Product / Process Change Notification (PCN)

PCN #: PCN_IndSL5HC_20210929

Affected Series: WE-SL5HC; 744273xxx

Before

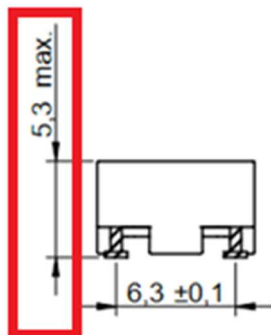
Due to an improvement of the production capability, Würth Elektronik will adjust the height tolerance of the components.

Height dimension: 5.3 mm (max)
